# Service Bulletin

## Using **260-0952** Alternator with Pre-2016 Stairmaster Units

Applies to: 4000-Steppers + SC916 + SC5+ FreeClimber (155015) 7000PT + SM916 + SM5+ Gauntlet (150015)

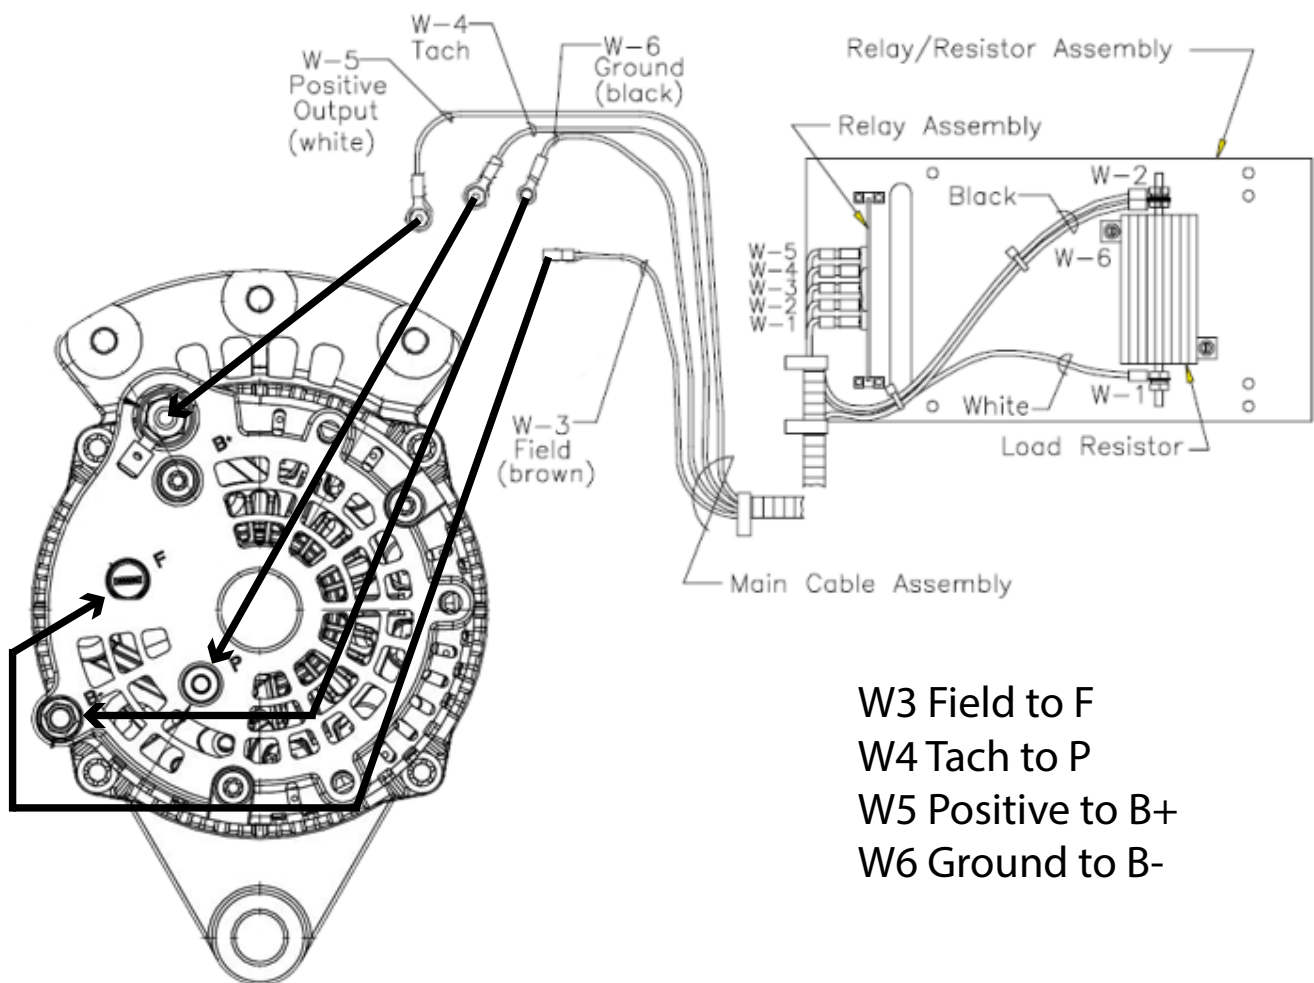
In 2018, a new alternator was introduced (**260-0952**) to replace the original Stairmaster alternator (**SM22900**). While this alternator is backwards compatible to pre-2016 units, the wires connect to it slightly different. Please see below:

W3 Field to F  
W4 Tach to B+  
W5 Positive to B+  
W6 Ground to B-
